RE: Eagle Creek Villas First Plat
Olsson Project #A20-24670

UPDATED POND REPORT

APPROVED PRELIMINARY STORMWATER DRAINAGE REPORT

Pond No. 1 - Water Quality Basin

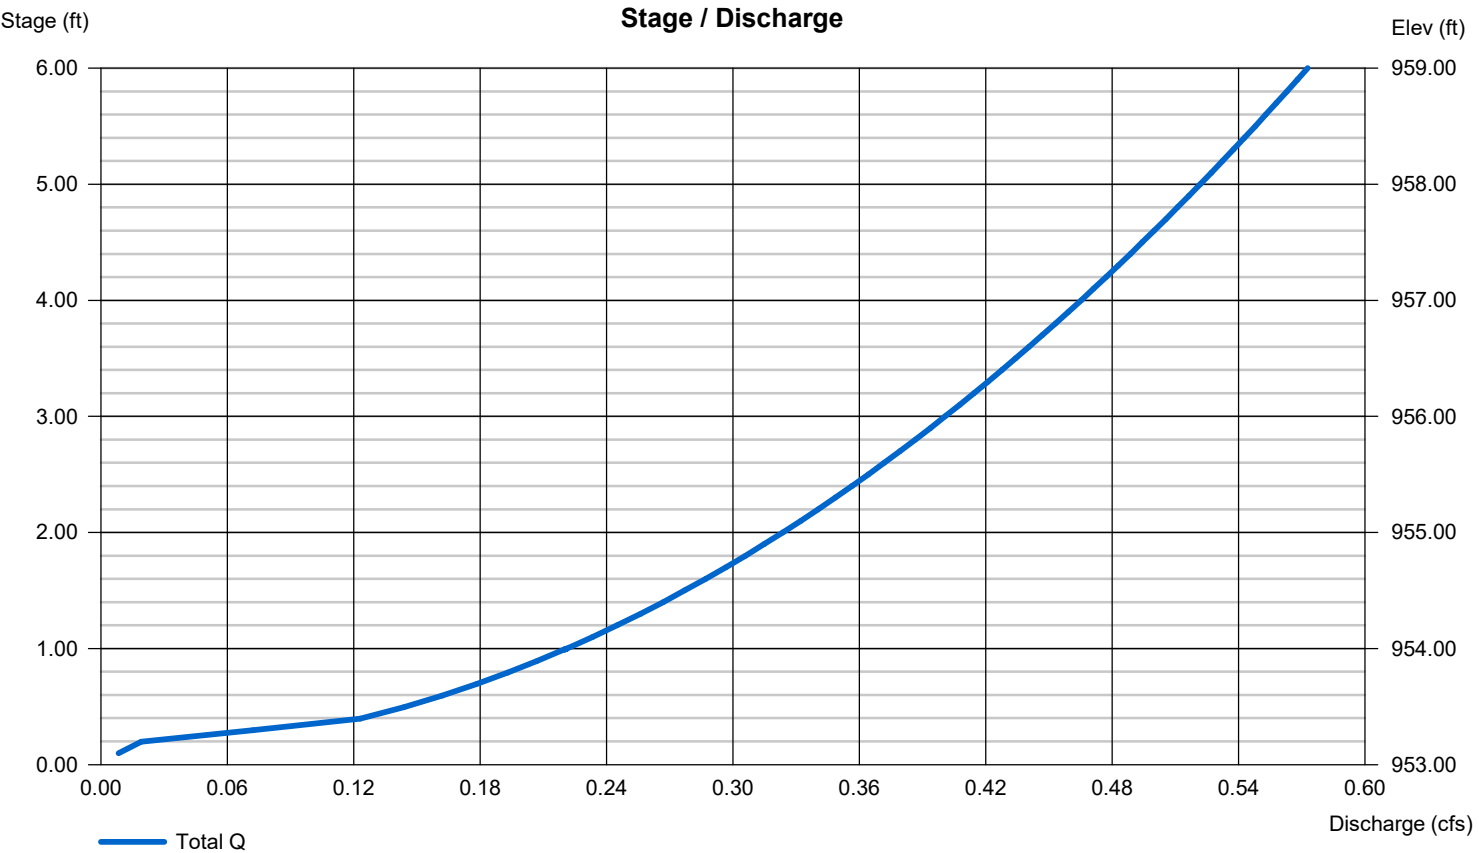
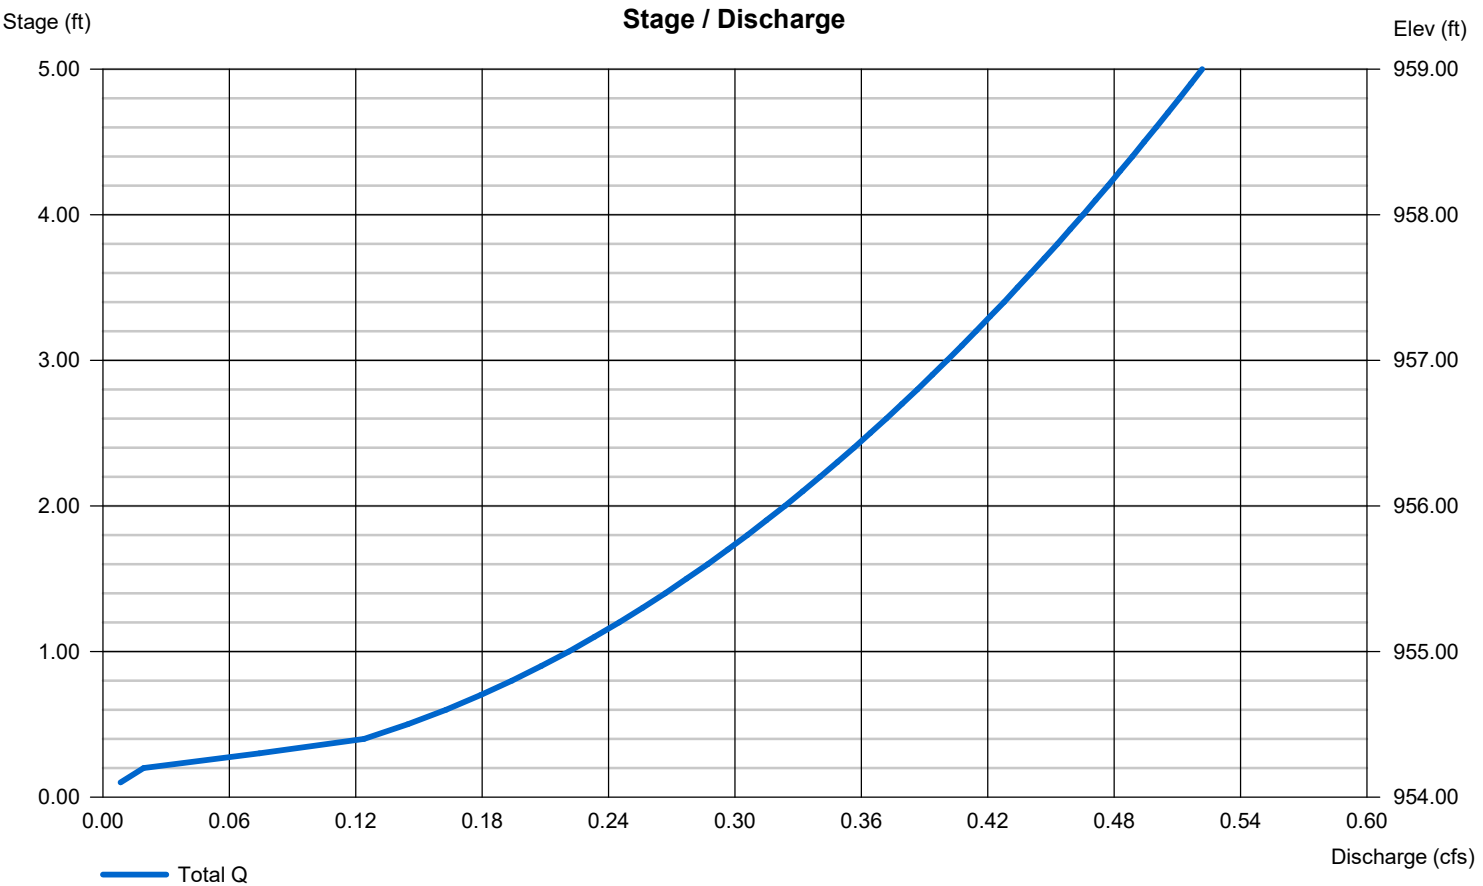
The impacts from the development of Eagle Creek Villas First Plat have been previously analyzed with the Eagle Creek Villas Stormwater Drainage Report. The only update to the approved stormwater report was an increase of the spillway length from 58' to 65'. This change is reflected in the plans and has also been revised in the Pond Report which is included in this letter. No other changes to the overall development have been made since the Eagle Creek Villas Stormwater Drainage Report was prepared and approved. The approved Eagle Creek Villas Stormwater Drainage Report has been included with this memo, for reference. Since the overall plan had only a minor change from the previously approved memo, we are requesting approval of this memo to satisfy stormwater drainage requirements for the Eagle Creek Villas First Plat development.

[A]	[B]	[C]	[D]
Crest Len (ft)	= 65.00	Inactive	Inactive	Inactive
Crest El. (ft)	= 959.00	0.00	0.00	0.00
Weir Coeff.	= 3.33	3.33	3.33	3.33
Weir Type	= Ciplti	Rect	---	---
Multi-Stage	= No	No	No	No
Exfil.(in/hr)	= 0.000 (by Wet area)			
TW Elev. (ft)	= 0.00
